Sustainable Communities Environmental Assessment Errata

5001 Wilshire Project

Case Number: ENV-2021-3327-SCEA
DIR-2021-3324-CLQ, DIR-2021-3326-TOC-SPR-VHCA, VTT-83358

August 2022

FIGURE II-5

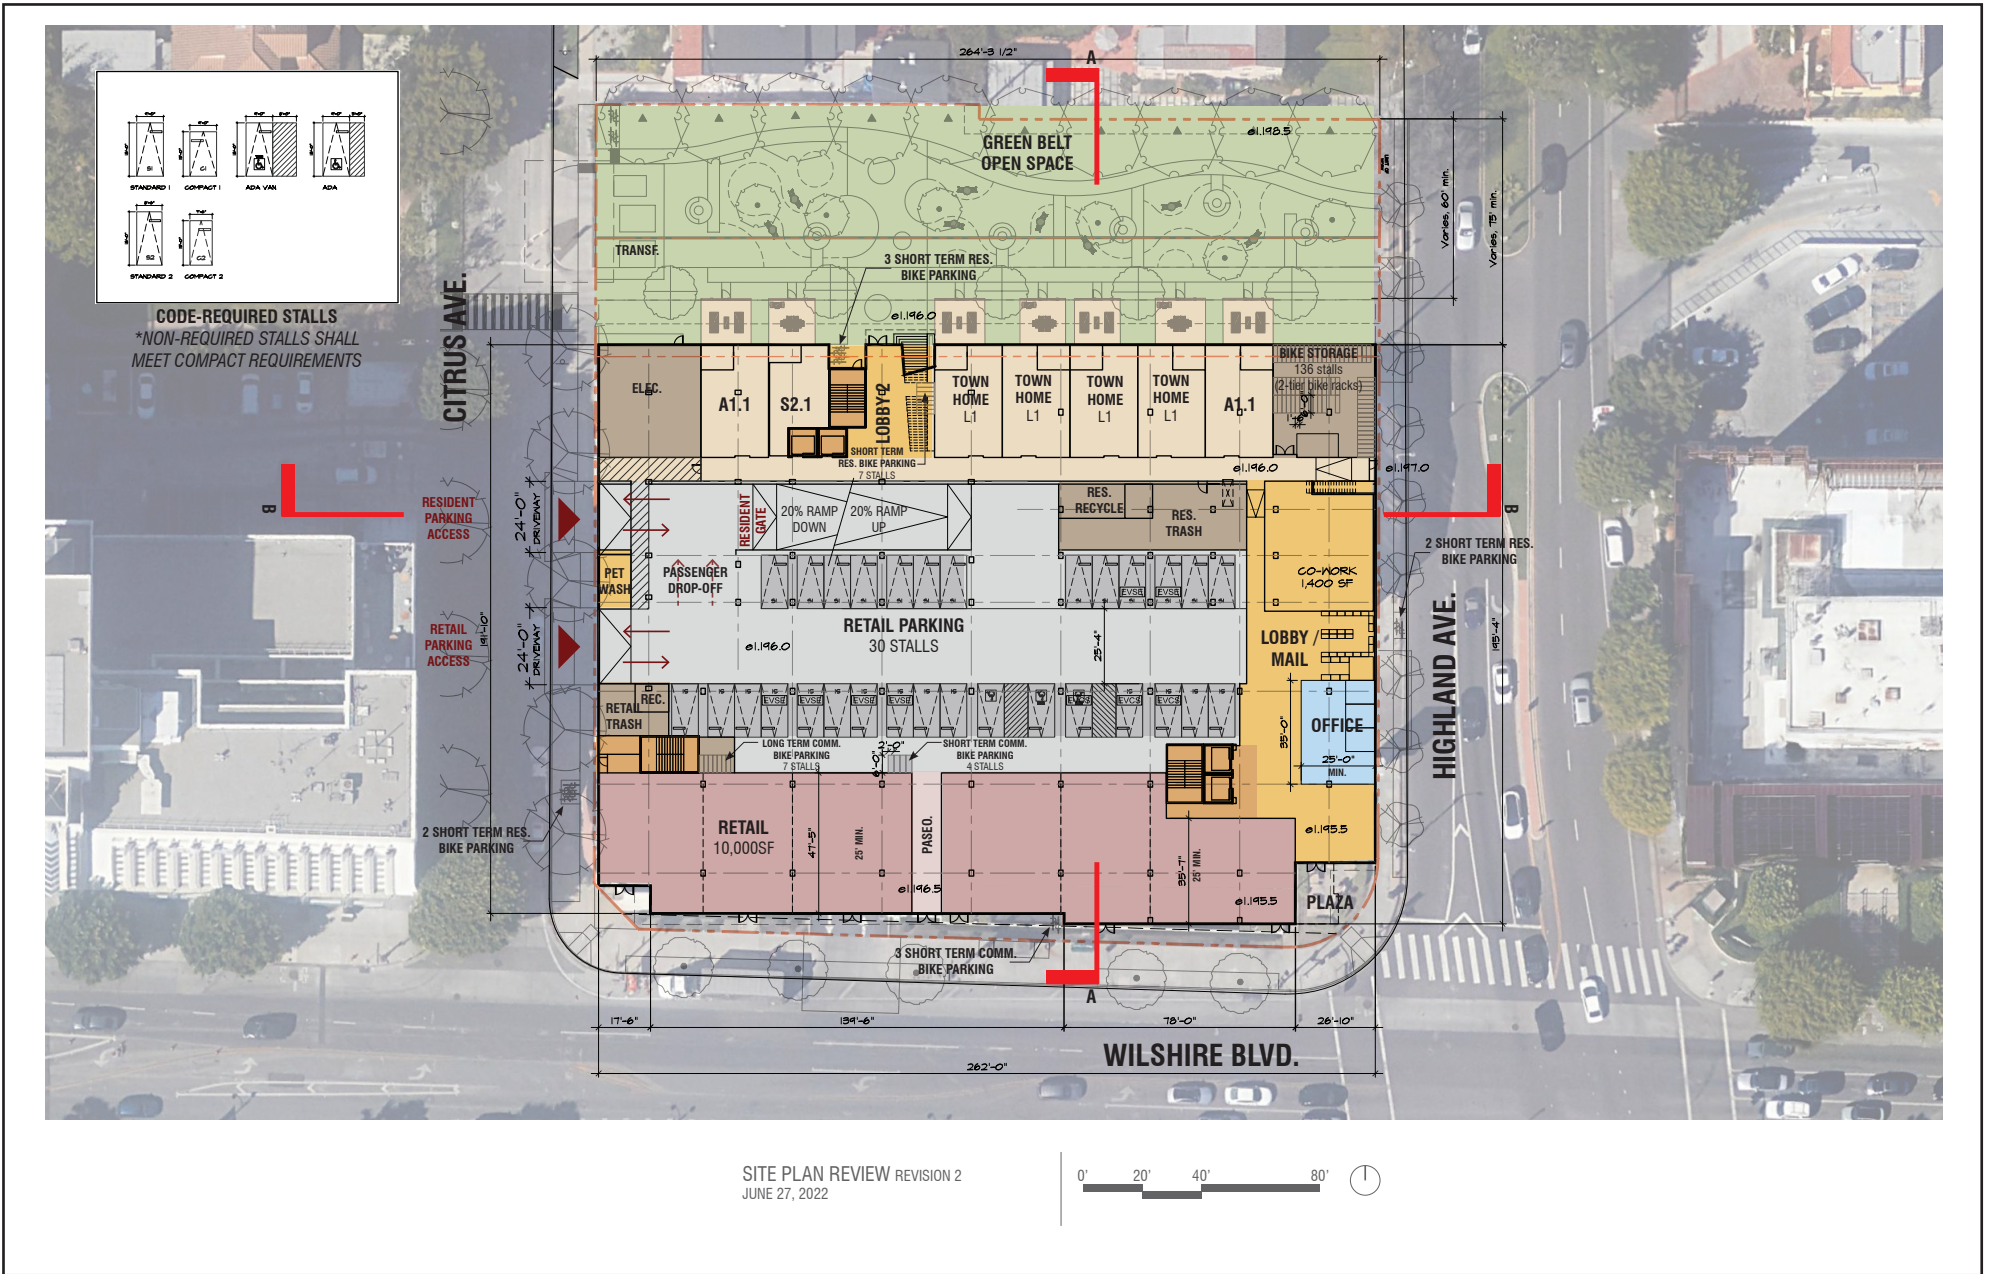
Figure II-5 Site First Floor Plan – this figure reflects minor updates made to the unit mix and their location, and updates to the bicycle parking and storage locations.

FIGURE II-7

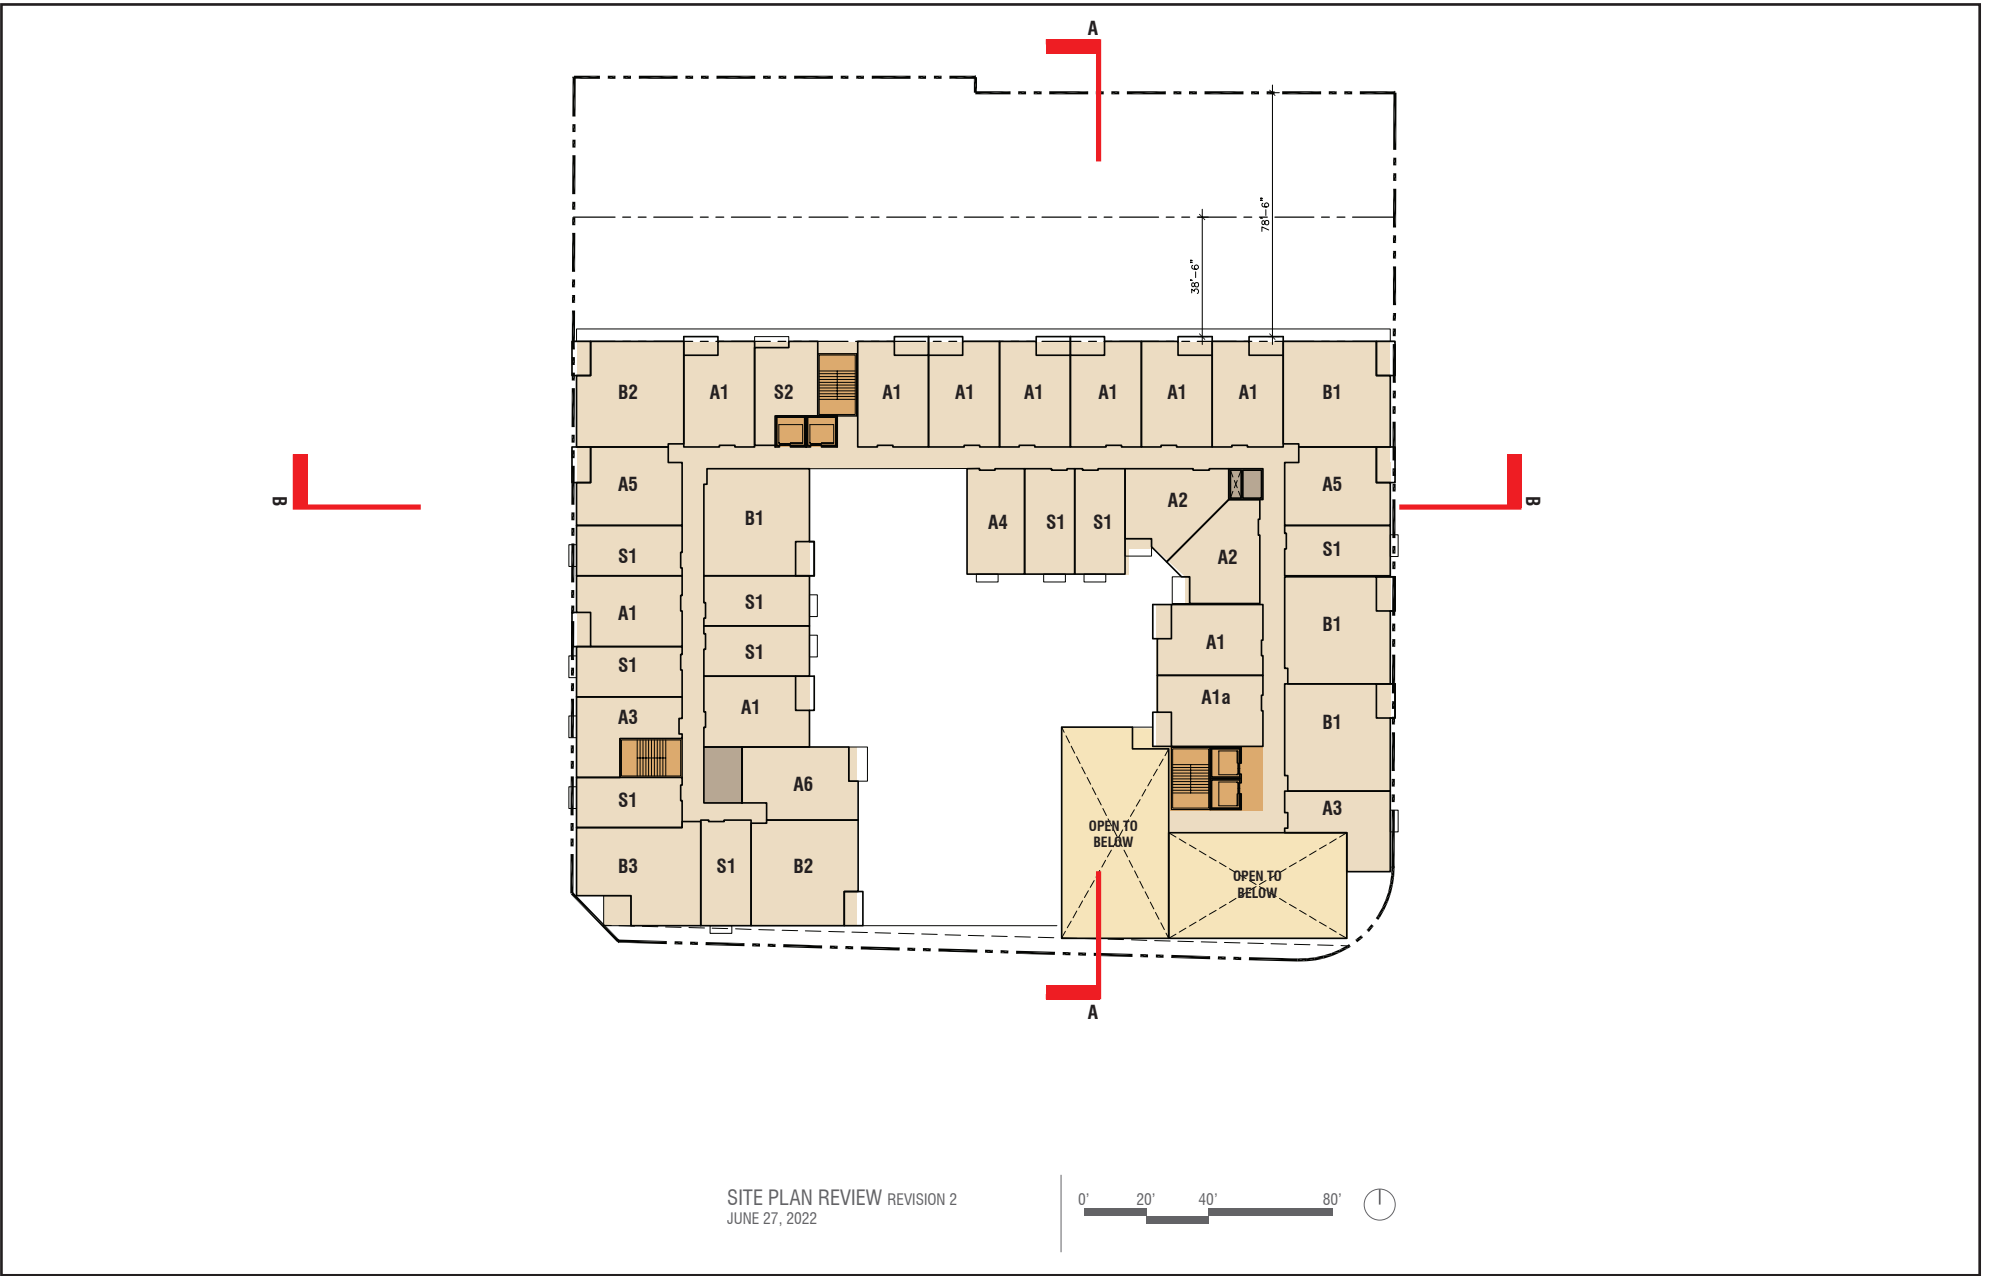
Figure II-7 Third Floor Plan - this figure reflects minor updates made to the unit mix and their location, and updates to the indoor amenities and their location.

FIGURE II-8

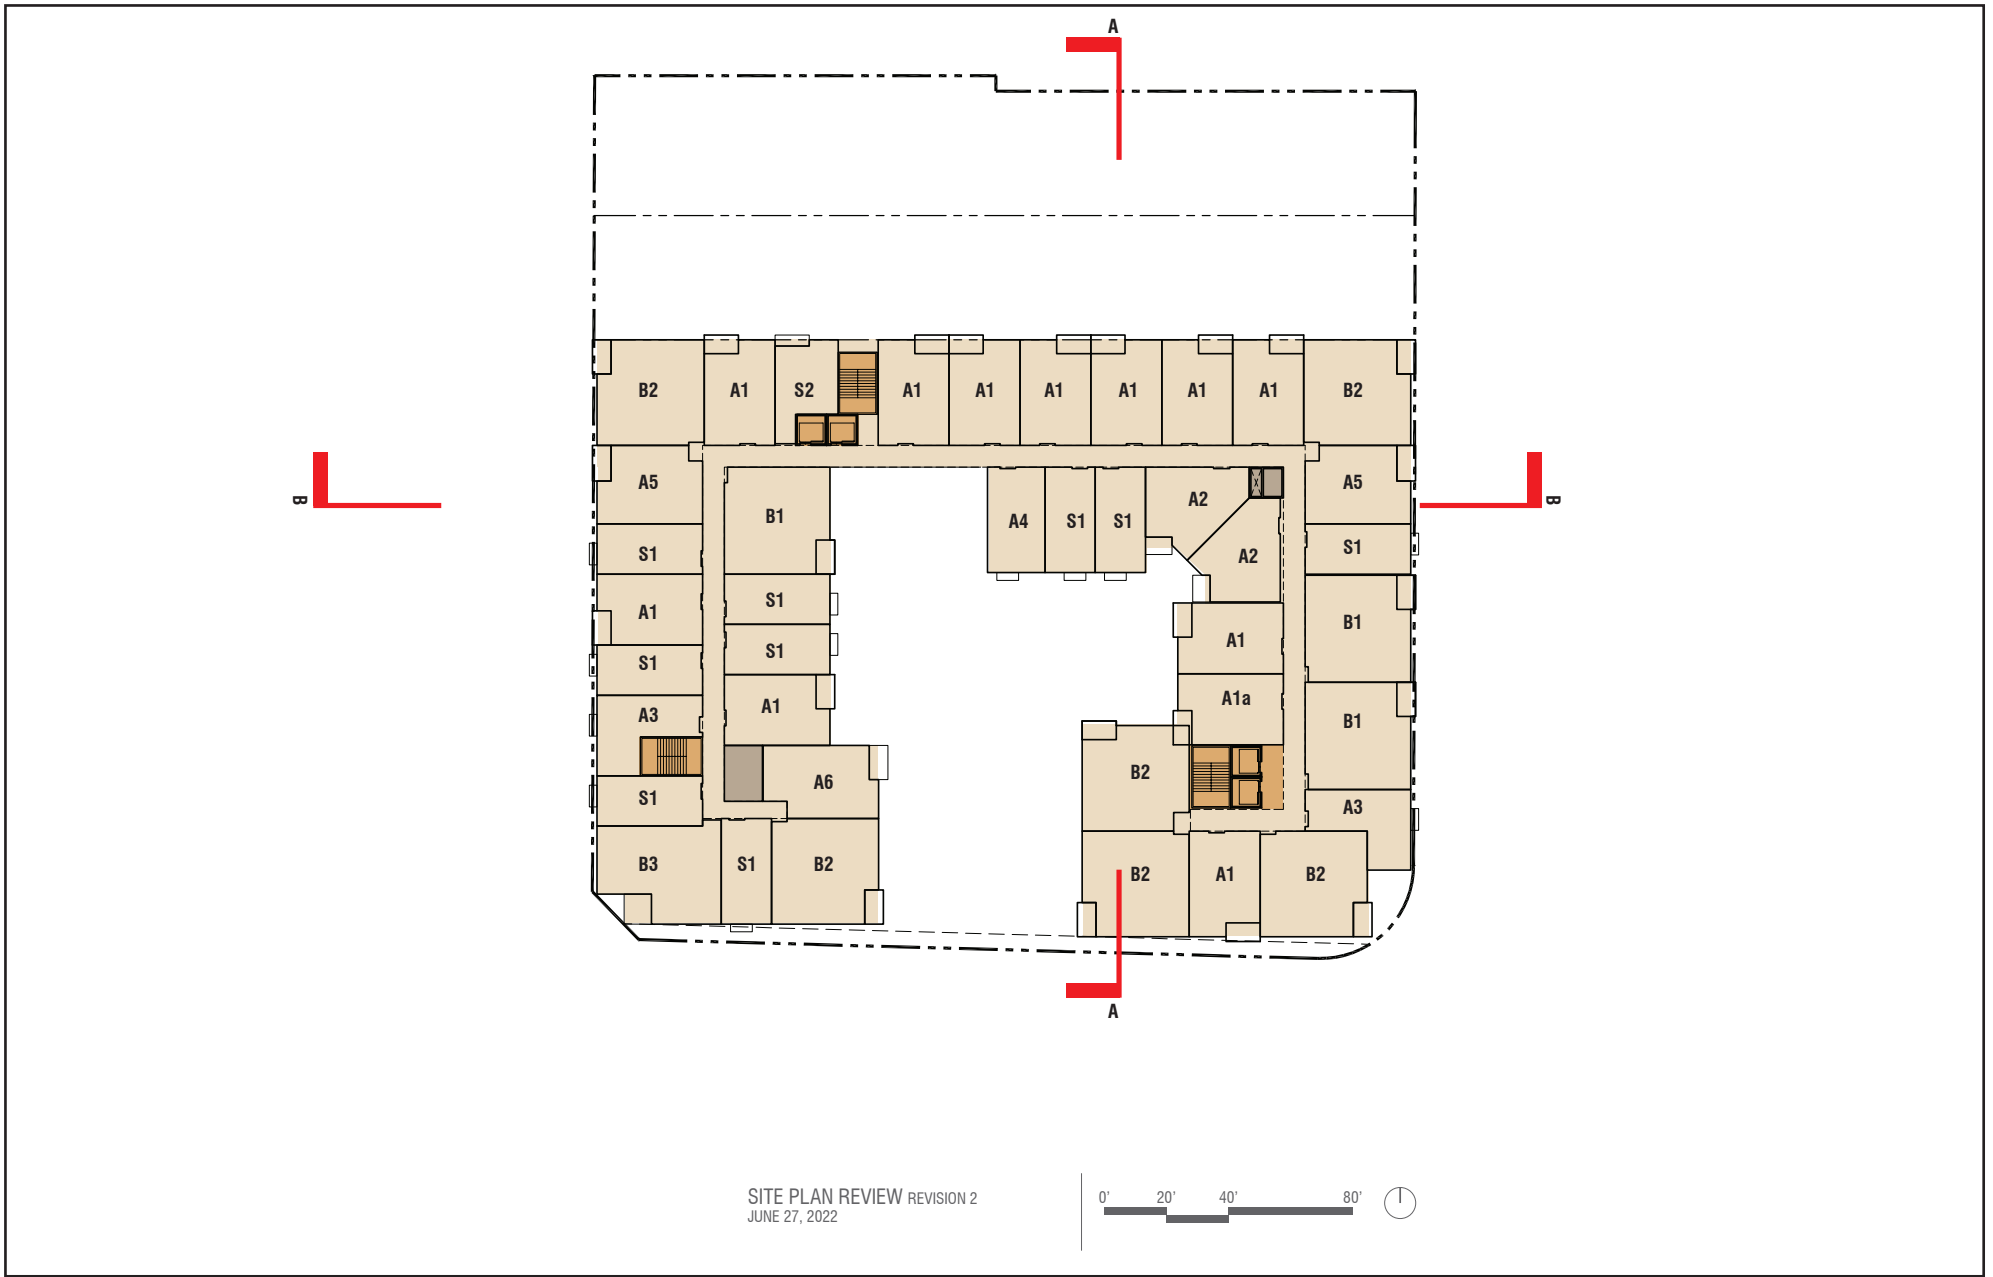
Figure II-8 Fourth Floor Plan - this figure reflects minor updates made to the unit mix and their location, and updates to the indoor amenities and their location.

FIGURE II-11

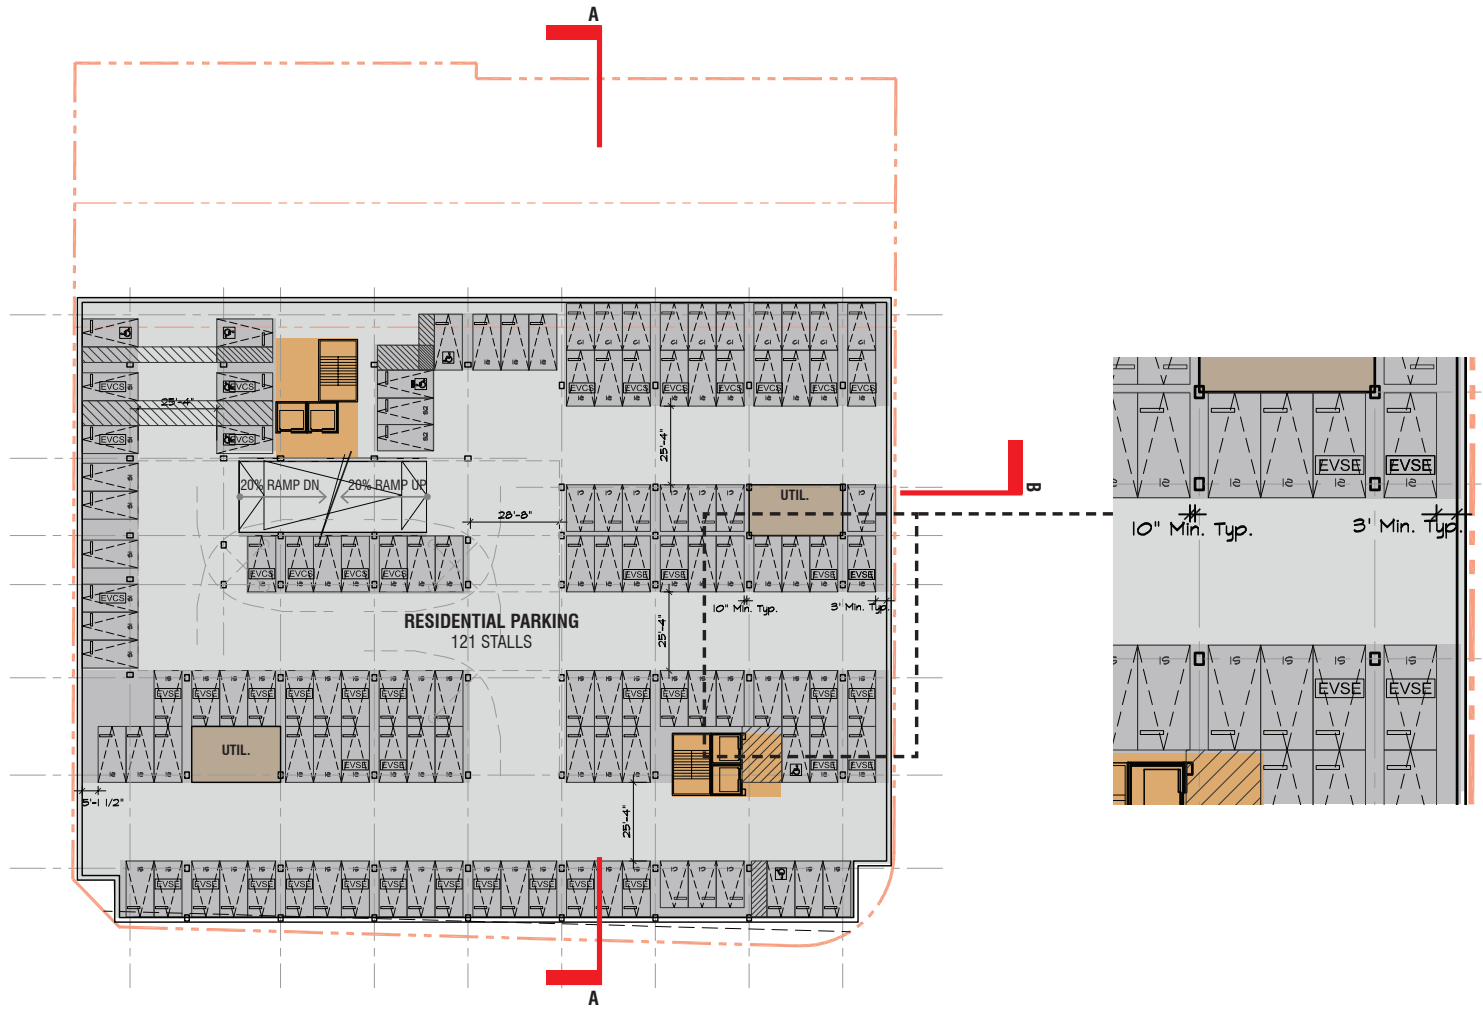
Figure II-10 Basement 1 Floor Plan - this figure reflects minor updates made to the arrangement of the residential parking stalls.

FIGURE II-12

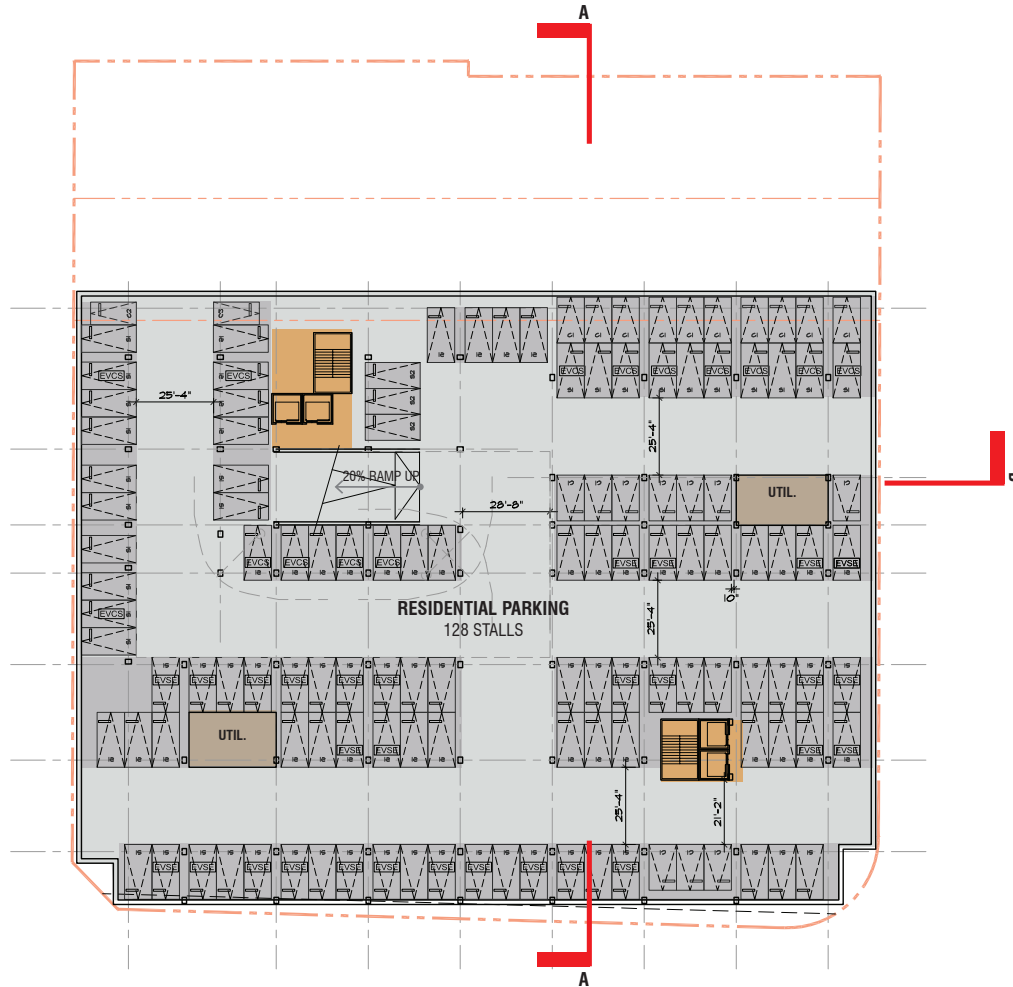
Figure II-12 Basement 2 Floor Plan - this figure reflects minor updates made to the arrangement of the residential parking stalls, and the elimination of the third basement level.
